DEVELOPMENT APPLICATION ASSESSMENT REPORT

Application Number:	DA2022/1392
Responsible Officer:	Olivia Ramage
Land to be developed (Address):	Lot 1 DP 511257, 49 Toronto Avenue CROMER NSW 2099
Proposed Development:	Alterations and additions to a dwelling house including a swimming pool and a secondary dwelling
Zoning:	Warringah LEP2011 - Land zoned R2 Low Density Residential
Development Permissible:	Yes
Existing Use Rights:	No
Consent Authority:	Northern Beaches Council
Land and Environment Court Action:	No
Owner:	Rebecca Louise Newton Alison Mary Michelle Cleary
Applicant:	Pdb Studio
Application Lodged:	20/09/2022
Integrated Development:	No
Designated Development:	No
State Reporting Category:	Residential - New second occupancy
Notified:	30/09/2022 to 14/10/2022
Advertised:	Not Advertised
Submissions Received:	0
Clause 4.6 Variation:	Nil
Recommendation:	Approval
Estimated Cost of Works:	\$ 290,000.00

Figure 1 - East elevation showing envelope breach

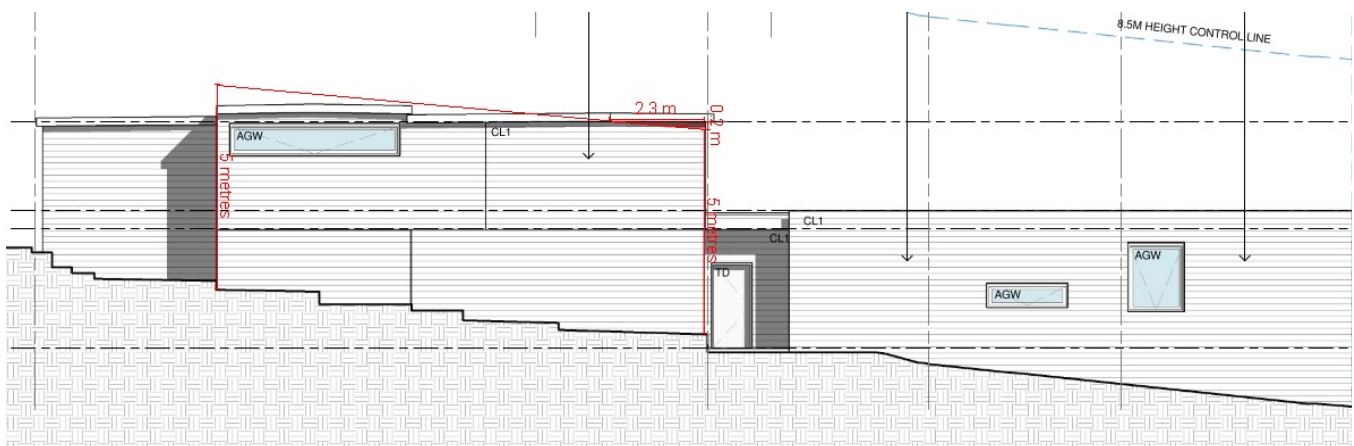
This control requires development to be sited within an envelope determined by projecting planes at 45 degrees from a height of 4.0m at the side boundaries. The proposed development presents a minor breach to the eastern side boundary envelope between nil and 0.2m for a length of 2.3m.

The envelope breach occurs largely as a result of the site's topography sloping towards the northern frontage where the breach occurs. The breach is constrained to the northern portion of the eastern facade of the dwelling and is considered to be minor. As such, the proposal responds well to the topography of the site.

Having regard to the above assessment, it is concluded that the proposed development is consistent with the relevant objectives of WDCP and the objectives specified in s1.3 of the Environmental Planning and Assessment Act, 1979. Accordingly, this assessment finds that the proposal is supported, in this particular circumstance.
